TO: T10 Membership
FROM: Paul A. Suhler, Quantum Corporation
DATE: 11 July 2006
SUBJECT: T10/05-049r4, SSC-3 Physical Device Model

Figure X – UML description of physical device

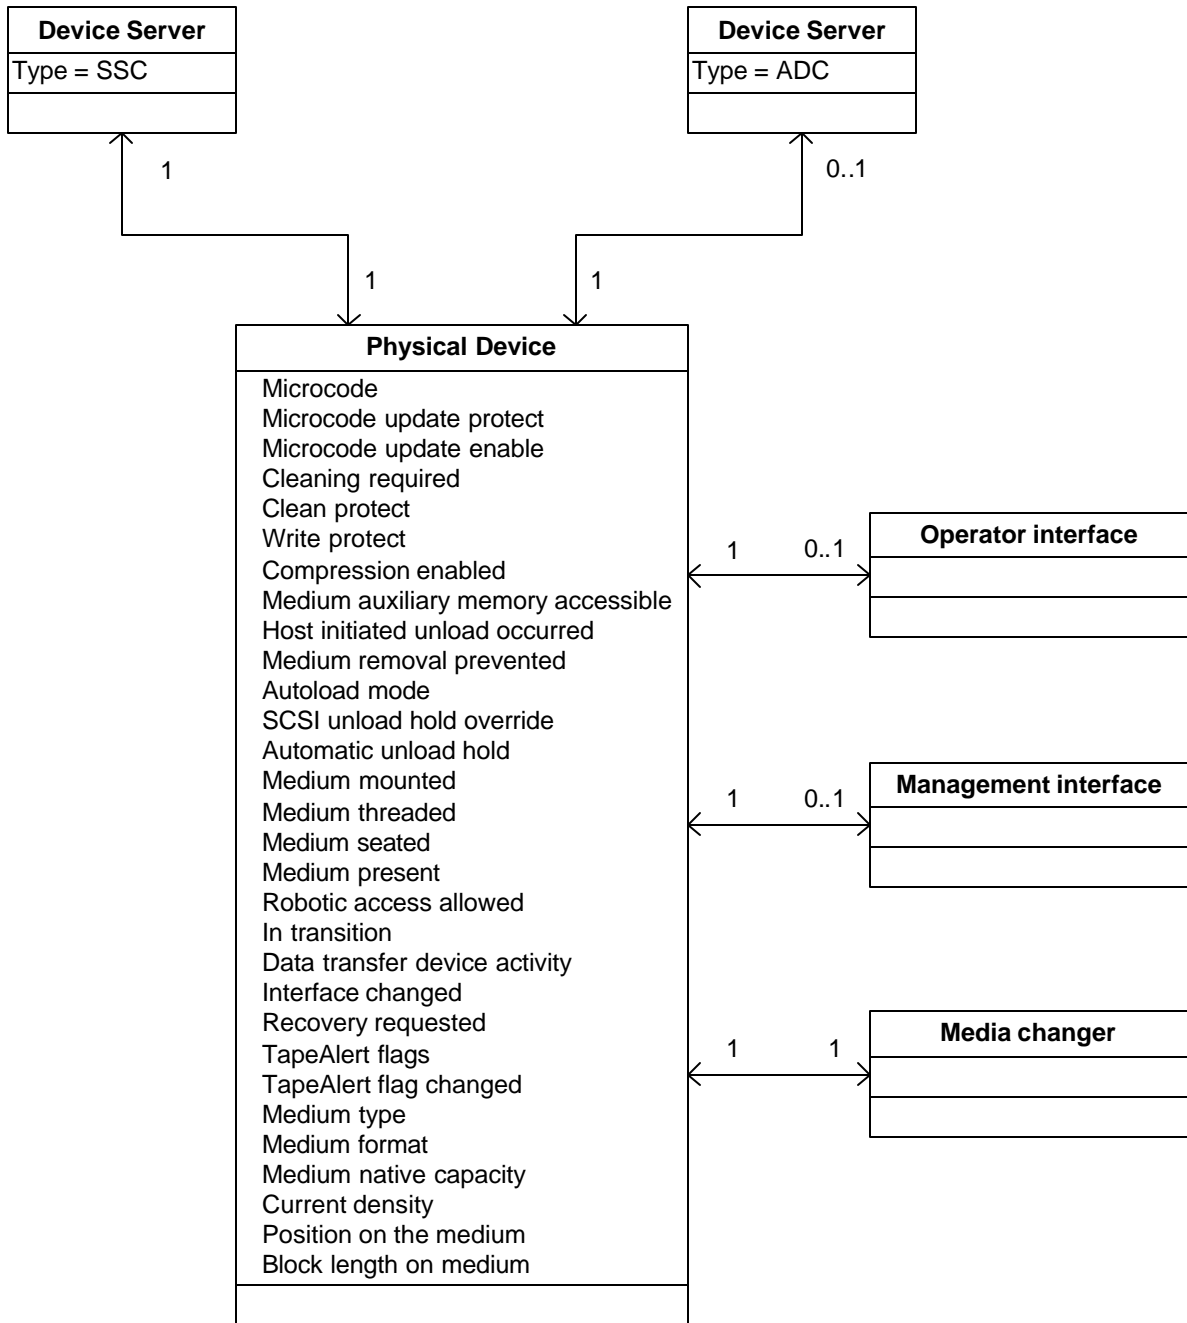
2. Add the following to clause 4.2 Sequential-access device model:

4.2.X Physical device

A sequential-access device contains one or more physical devices. A physical device performs operations upon the medium (e.g., loading, unloading, positioning, writing and reading the medium, and reading and writing medium auxiliary memory).

The physical device is controlled by various entities, which may include:

- a) One or more SCSI device servers (e.g., SSC and ADC);
- b) An operator interface;
- c) A management interface; and
- d) A media changer.

A media changer may control the physical device by inserting a medium into the device. The operator can be considered to be a media changer for purposes of medium insertion and removal.

These entities perform operations that change various attributes of the physical device. These attributes affect the operations on a volume. Figure X shows in UML notation an example of the entities in a SCSI target device, and shows the attributes which comprise the physical device.
